# Groundwater Transfer Review Summary Form

Transfer/PA # T- 14739

Application: T-14739

Applicant Name: Bruce Ernst

Map

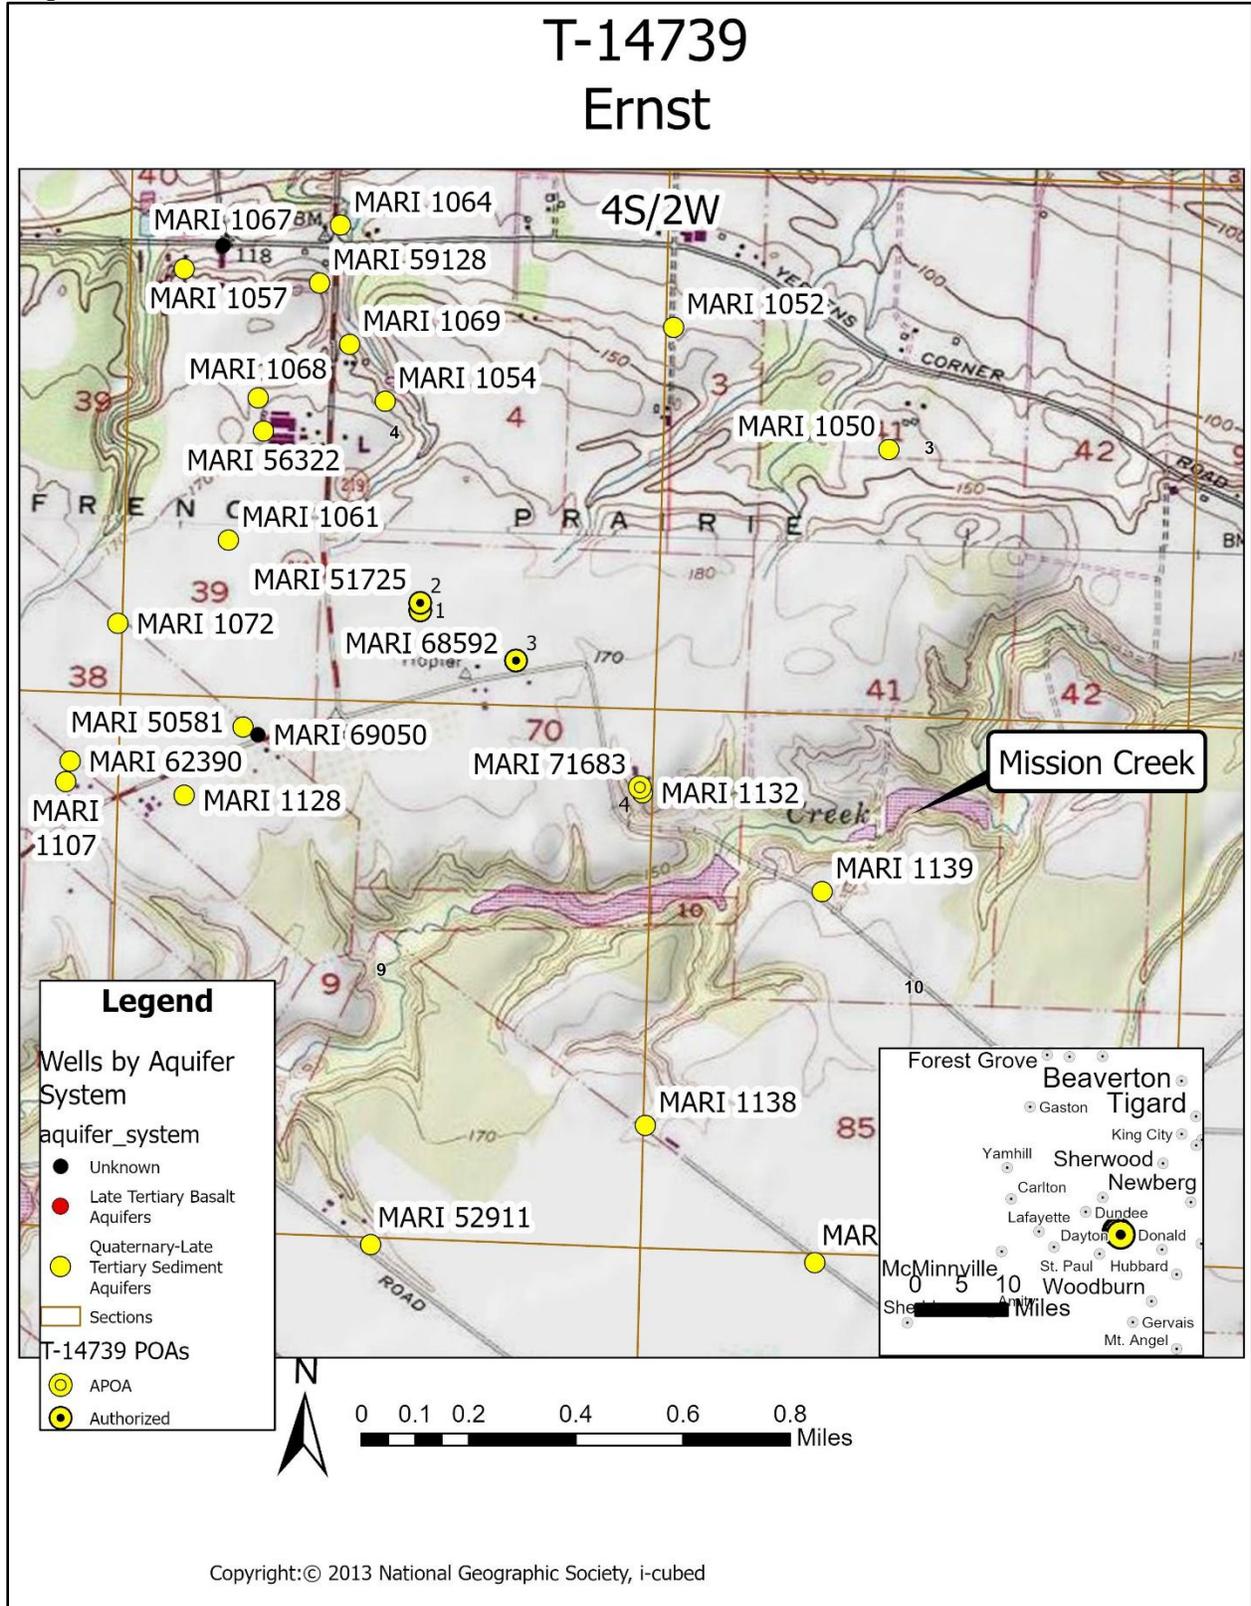
5. a) Will this proposed change, at its maximum allowed rate of use, likely result in an increase in interference with **another ground water right**?  
 Yes    No   Comments: The proposed APOA, POA 4/Well 5 (MARI 71683), is closer than the authorized POAs to neighboring well MARI 1139, which is an authorized POA under Certificate 42424. The closer proximity of the proposed APOA to MARI 1139 will likely result in an increase in interference with MARI 1139.

Yes  No Comments: The proposed APOA, POA 4/Well 5 (MARI 71683) is closer to Mission Creek than the authorized POAs. Mission Creek is hydraulically connected to the alluvial aquifer system tapped by the authorized POAs and the APOA. Therefore, the closer proximity of the proposed APOA will likely increase interference with Mission Creek.

Theis Interference and Injury Analysis: POA 4/Well 5 (MARI 71683)-MARI 1139

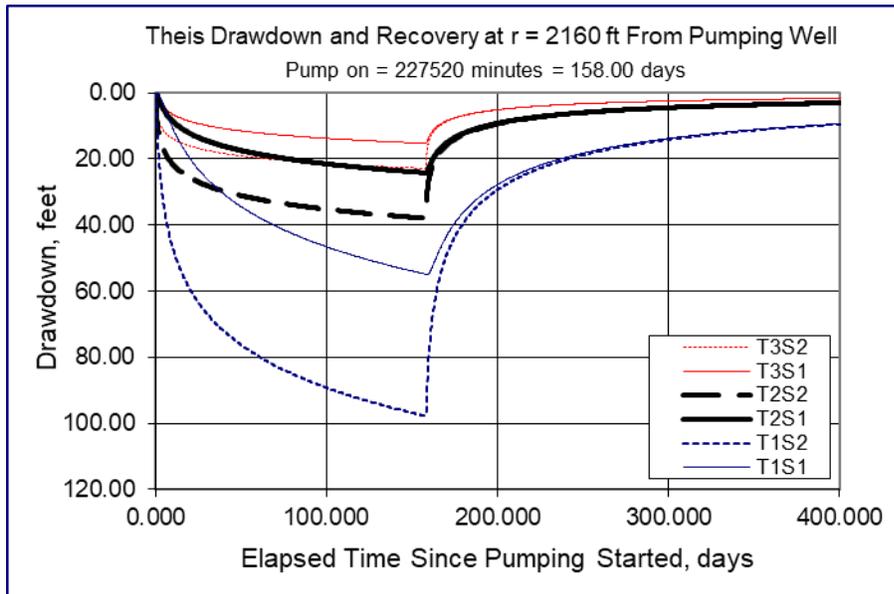
b) If yes, would this proposed change, at its maximum allowed rate of use, likely result in another groundwater right not receiving the water to which it is legally entitled?  
 Yes    No   If yes, explain: The proposed APOA, POA 4/Well 5 (MARI 71683) is approximately 2,160 ft northwest of MARI 1139. The Theis (1935) solution for drawdown in a confined aquifer was used to assess the potential for injury to MARI 1139 from the proposed changes (see attached Theis Interference and Injury Analysis). Results indicate the proposed change is unlikely to result in MARI 1139 no receiving the water to which it is legally entitled.

Radius,  $r=2,160$  ft [approximate distance from Well 5 to MARI 1139]

Pumping time,  $t=158$  days [approximate time to exhaust combined duty at max combined rate]

Pumping rate,  $Q=1.92$  cfs [max combined rate]

Transmissivity:  $T1=700$  ft<sup>2</sup>/day,  $T2=2,200$  ft<sup>2</sup>/day,  $T3=4,000$  ft<sup>2</sup>/day [Pumping Test Reports]

Storativity:  $S1=0.003$ ,  $S2=0.0003$  [Conlon et al., 2005]
